ZS-2013-0194

Zion Nuclear Power Station, Units 1 and 2
Facility Operating License Nos. DPR-39 and DPR-48
NRC Docket Nos. 50-295 and 50-304

Subject: Updated Request for Amendment to Approve Methods of Analysis, use of the Upgraded Fuel Handling Building Crane System as a Single-Failure Proof Crane and Approval of a NUREG 0612 Compliant Heavy Loads Handling Program

Replace Figure 3-34 in the DSAR with this Figure

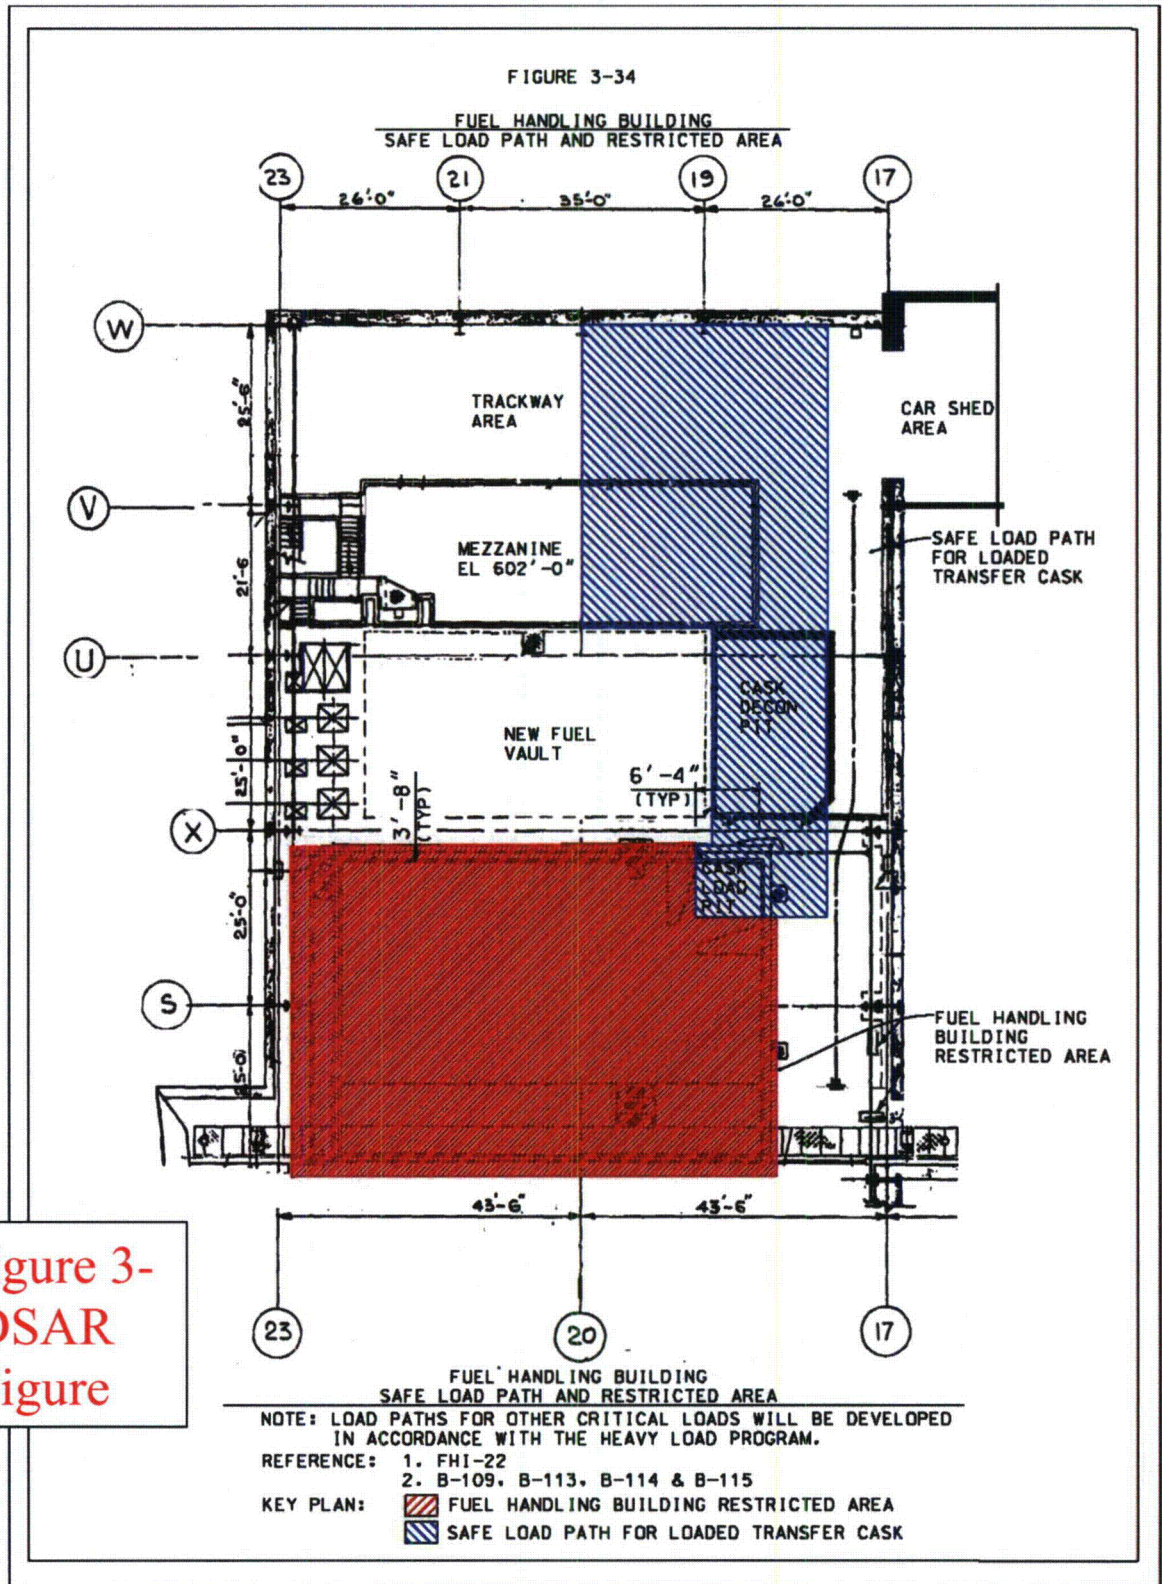
The safe load path for handling the loaded cask will be shown in revised DSAR Figure 3-34. Handling of the MTC will be performed using a specially designed yoke as specified by NAC and described in the MAGNASTOR Safety Analysis Report. Safe load paths for other lifts listed above will be controlled as required by the Heavy Loads Program attached.

Figure 3-35
 CASK OVER STORAGE AREA -
 LOOKING SOUTH
 AUGUST 1960

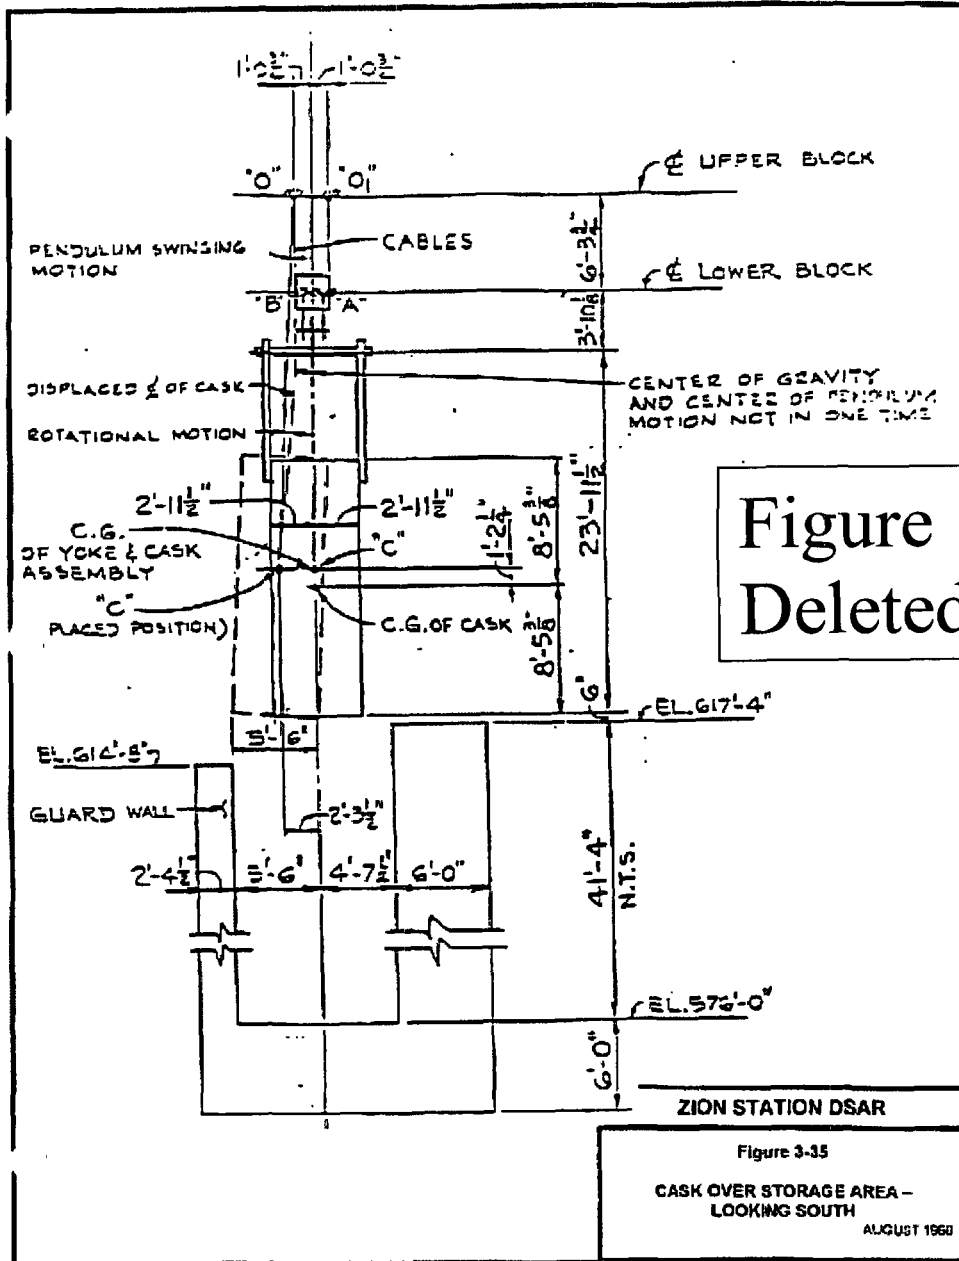
Figure Deleted
